**TO:** Planning Board  
**FROM:** Chandler Van Schaack, Case Manager  
**DATE:** August 6, 2015  
**SUBJECT:** **Call Up Item:** Hawthorn 711 Subdivision (LUR2015-00037): Minor Subdivision to subdivide one 0.34-acre developed lot at 711 Hawthorn St. to create 2 new residential lots: Lot 1 (7,605 s.f.) and Lot 2 (7,321 s.f.). Lot 1 will contain the existing single family home. The call up period expires on **August 10, 2015**.

**CITY OF BOULDER PLANNING DEPARTMENT  
NOTICE OF DISPOSITION**

DECISION: **APPROVED**  
PROJECT NAME: **Hawthorn 711 Subdivision**  
DESCRIPTION: **MINOR SUBDIVISION to divide the property into two lots:  
Lot 1 (7,605 sf) and Lot 2 (7,321 sf).**  
LOCATION: **711 Hawthorn Ave.**  
COOR: **N05W07**  
LEGAL DESCRIPTION: **See Attached Exhibit A**  
APPLICANT: **Anthony Kimbiris**  
OWNER: **Antoinette Piaggio**  
APPLICATION: **Minor Subdivision, LUR2015-00037**  
ZONING: **RL-1**  
CASE MANAGER: **Chandler Van Schaack**

**FINAL PLAT**  
**HAWTHORN 711 SUBDIVISION**  
 A SUBDIVISION OF A TRACT OF LAND LOCATED IN THE SOUTHEAST QUARTER OF SECTION 24, TOWNSHIP 1 NORTH, RANGE 71 WEST OF THE 6TH P.M., CITY OF BOULDER, COUNTY OF BOULDER, STATE OF COLORADO  
 TOT

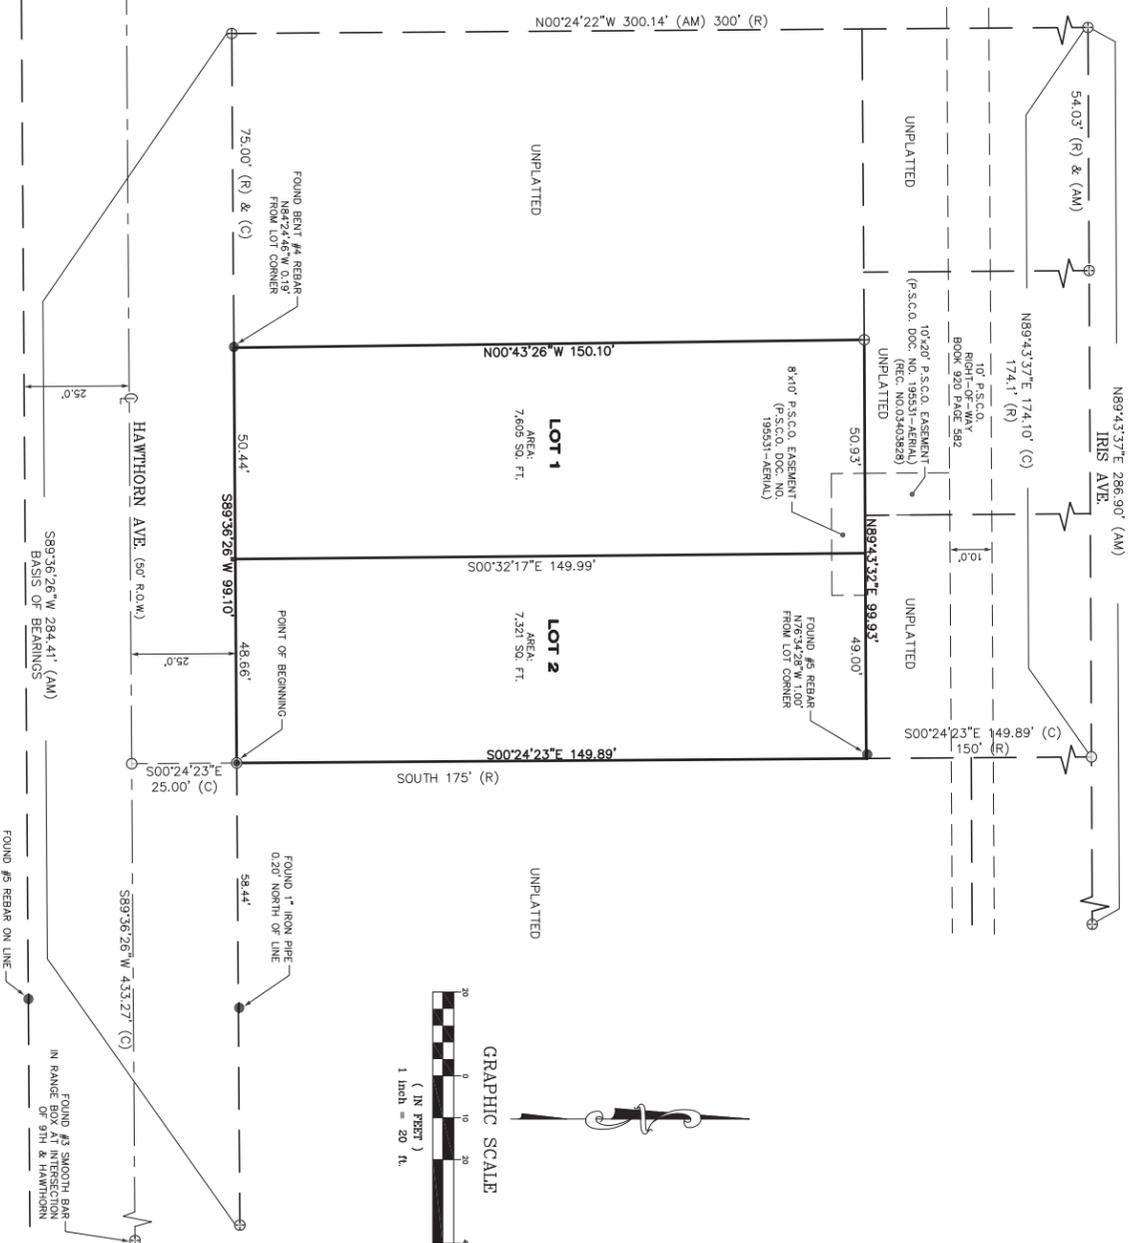
- (b) In order to obtain city manager review of a final plat, the subdivider shall submit a final plat that conforms to the approved preliminary plat, includes all changes required by the manager or the planning board, and includes the following information:

- (4) Accurate dimensions for all lines, angles and curves used to describe boundaries, public improvements, easements, areas to be reserved for public use and other important features. (All curves shall be circular arcs and shall be defined by the radius, central angle, tangent, arc and chord distances. All dimensions, both linear and angular, are to be determined by an accurate control survey in the field that must balance and close within a limit of one in ten thousand. No final plat showing plus or minus dimensions will be approved.);

- (8) The total acreage and surveyed description of the area;

- (9) The number of lots and size of each lot;

- (17) The square footage of each lot;

*Standard met.*

*Standard met.*

*Standard met.*

*Standard met.*

*Standard met.*
